Western Digital Corporation  
20511 Lake Forest Drive  
Lake Forest, CA 92630

To: T10 CAP Working Group  
Contact: Curtis E. Stevens  
Phone: 949-672-7933  
Email: Curtis.Stevens@wdc.com  
Date: July 14, 2008

Subject: UAS Clause 4 (Model)

The following text replaces clause 4 of UAS

Figure 1 — USB Model

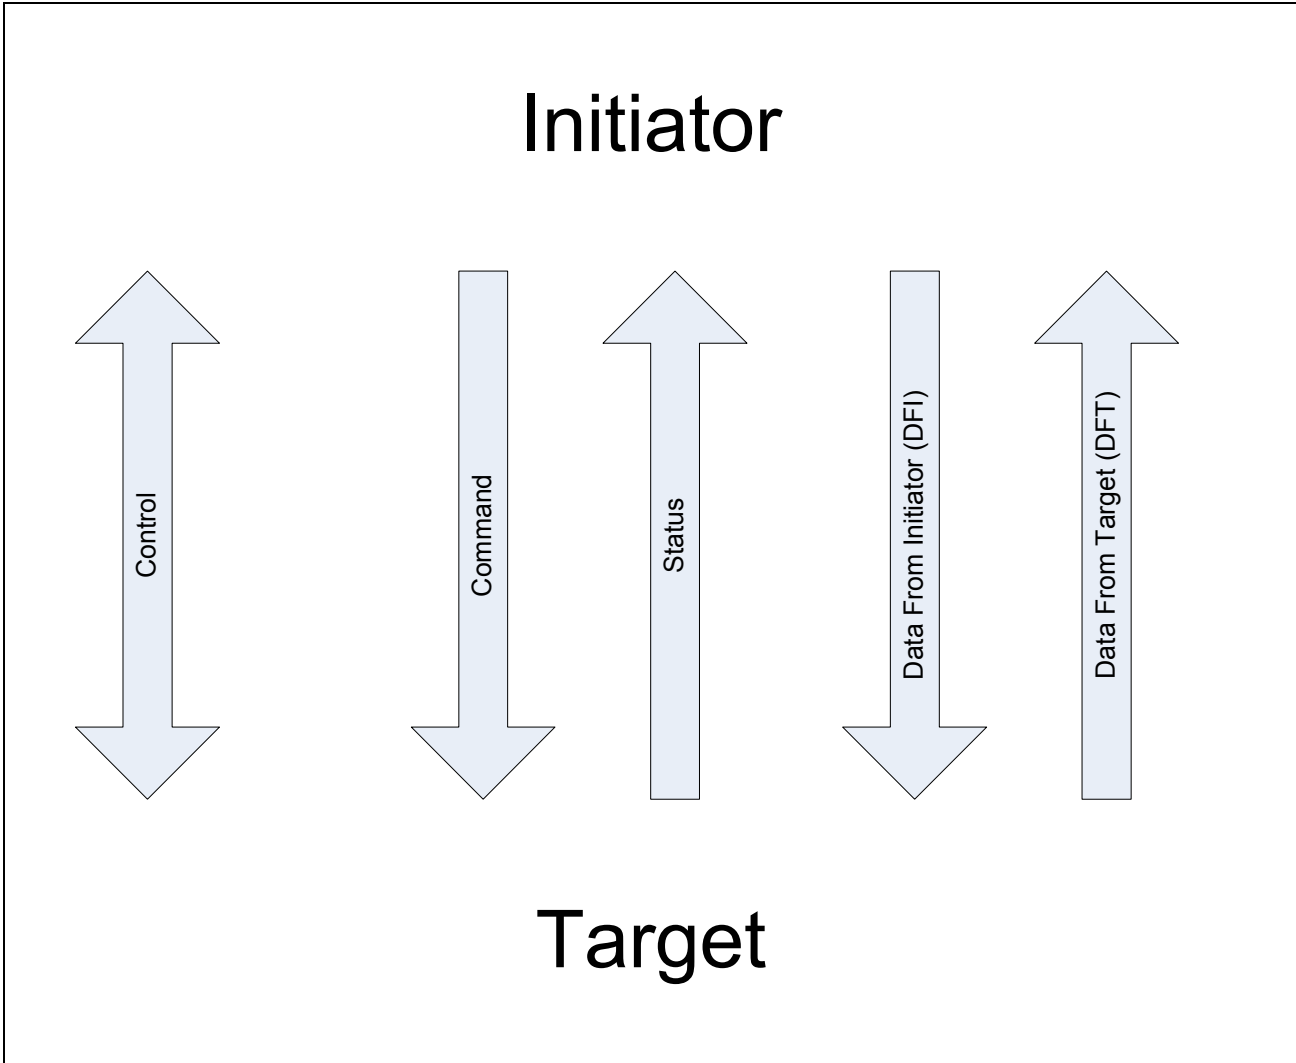
USB devices implementing this standard shall support full or high speed operation as defined by the USB-20 specification. The minimum configuration for a UAS target is one Control pipe, two Bulk-in pipes, and two Bulk-out pipes. UAS targets shall only support a single initiator. Figure 1 describes the relationships of the pipes in a UAS target.

The Control pipe is a required by USB-20, and is not used by this standard.

The target receives Information Units (IUs) from the initiator using the Command pipe and responds with IUs using the status pipe.

The Data From Initiator and Data From Device pipes are for transferring data between the initiator and target.
